Response to
Staff memorandum in response to expert reports submitted for Rangen Delivery Call

Charles M. Brendecke, PhD, PE
AMEC Environment & Infrastructure

April 5, 2013

Figure A.1 – Trimline Comparisons ESPAM2.0 and 2.1 (Revised Figure 4.10)

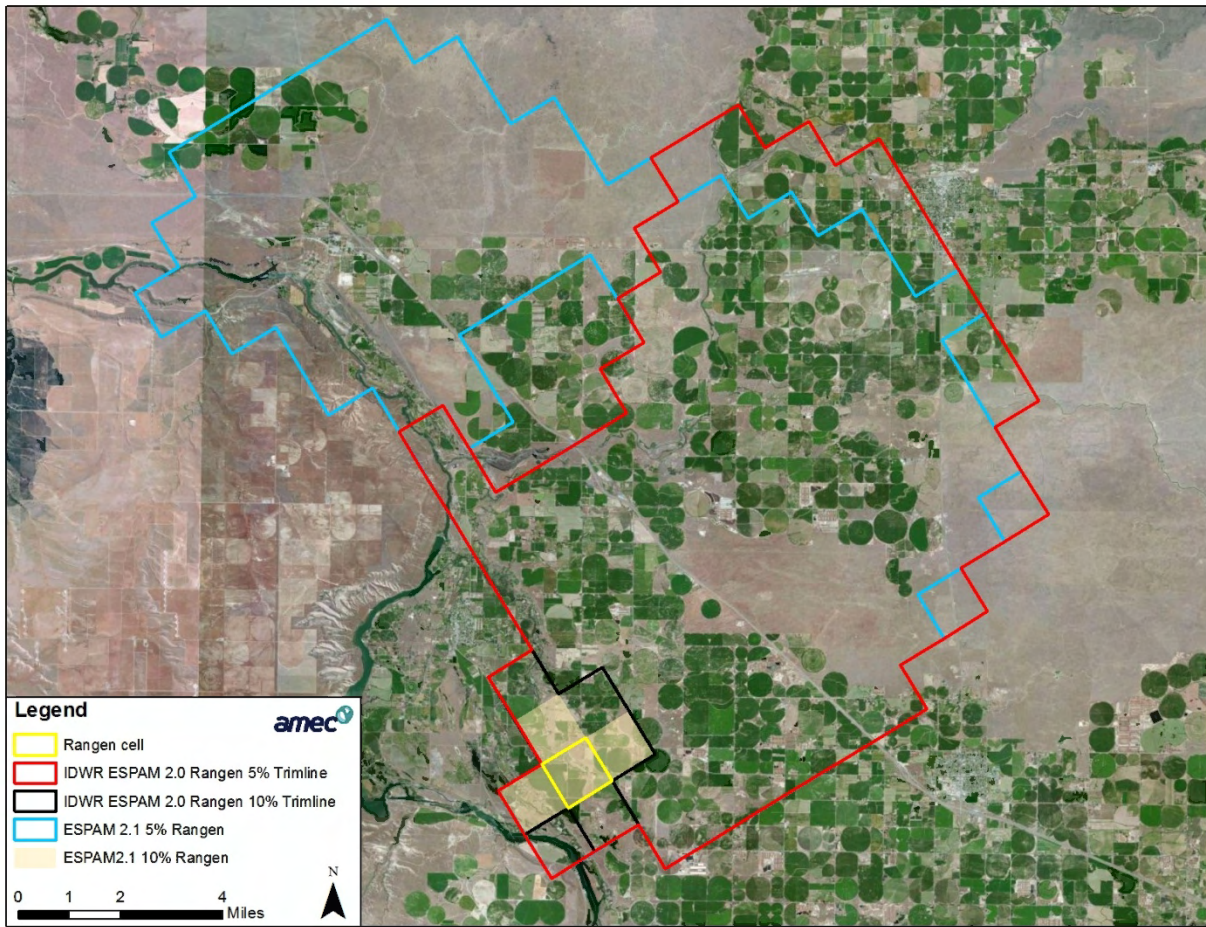
On page 38, the staff memo contains the following statement regarding AMEC’s use of the 10% trimline: “It appears that Dr. Brendecke did not use the correct 10% trimline in his analysis performed with ESPAM2.1. AMEC’s model files show that pumping was applied in model cells 1041014 and 1043013, which both have steady state response functions of 9.53% with respect to the Rangen spring complex.”

This error occurred because I allowed steady state response values greater than 9.5% to be rounded up to 10% before defining the trimline, whereas IDWR does not consider such rounding. Attachment A contains the relevant tables and figures from my report that reflect this correction.

Figure A.1 is updated from Figure 4.10 in my 12/21/2012 expert report. The corrections shown in this figure are updated 5% and 10% ESPAM2.1 trimlines.

Figure B.1 – Trimline Comparisons ESPAM2.1 and AMEC Alternative Model

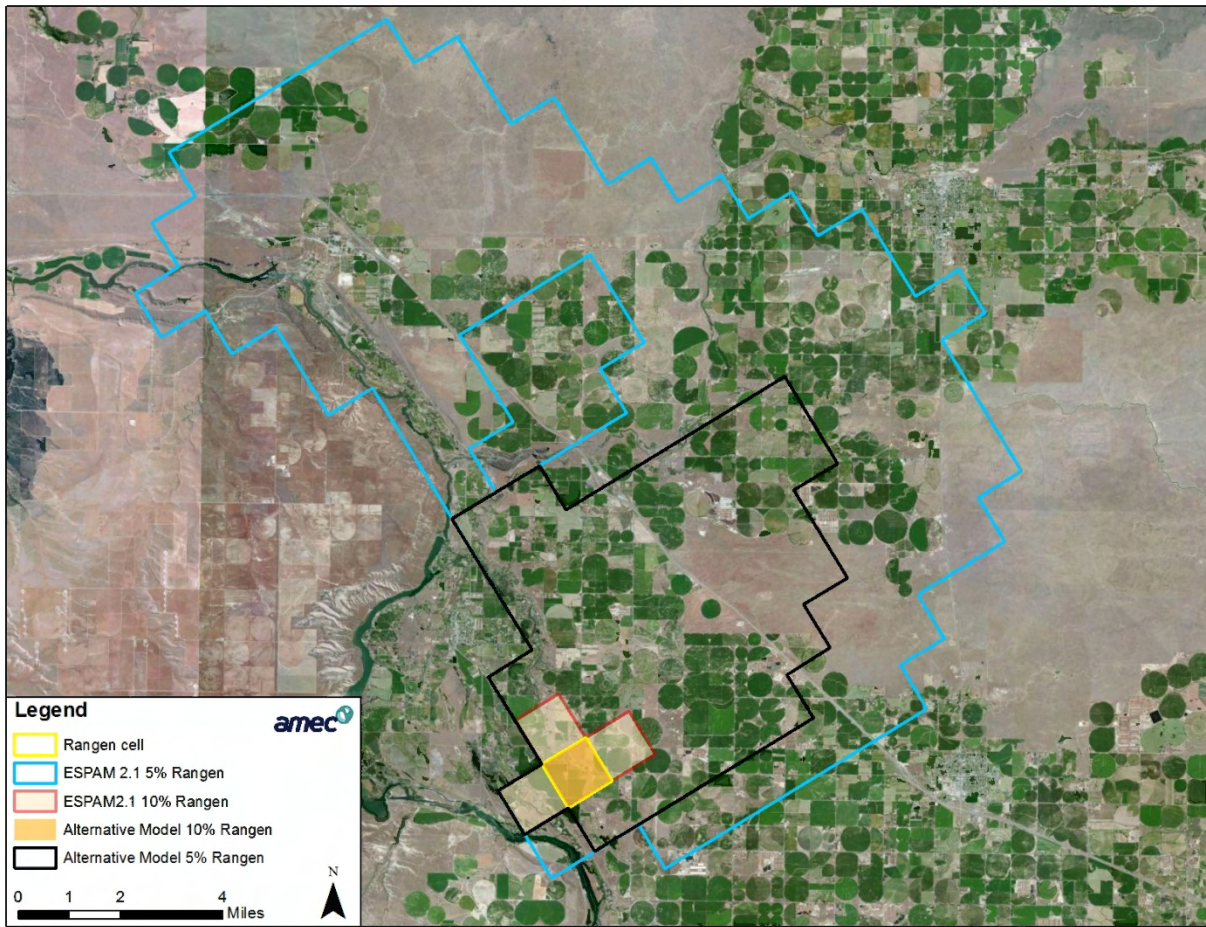
On pp. 38-39 of the staff memo, IDWR staff present an evaluation of alternative models presented in my December report. Among other things, they ran the alternative models for a scenario of full curtailment across the model domain. I believe this full domain curtailment scenario to be an inappropriate use of the alternative models as they were recalibrated only for parameters in the CRIV group, which includes drain, river bed and general head boundary conductance parameters. The alternative models were not recalibrated for transmissivities anywhere in the model domain. As a result, the regional pathways of groundwater flow toward

the Hagerman Rim are the same in the alternative models as they are in ESPAM2.1. I would expect that curtailment across the model domain using all these models would be similar.

In the process of correcting the errors noted at the beginning of this response, I developed a composite of my two alternative models and allowed PEST to recalibrate transmissivities in this composite model across roughly the western half of the model domain (74 pilot points), as well as to all the targets used in my original alternative analyses. This gives PEST an opportunity to adjust regional flow pathways in response to the conceptual modifications I made in my alternative models.

I then ran a full domain curtailment analysis comparable to that done by IDWR for ESPAM2.1 and shown in Table 3 of the staff memo. The results of this analysis show differences at both the 10% trimline, 5% trimline and full domain curtailments. Details of this recalibration are contained in Attachment B.

Figure B.1 is similar to Figure A.1. It compares the trimlines generated by ESPAM2.1 and the AMEC recalibrated alternative model.
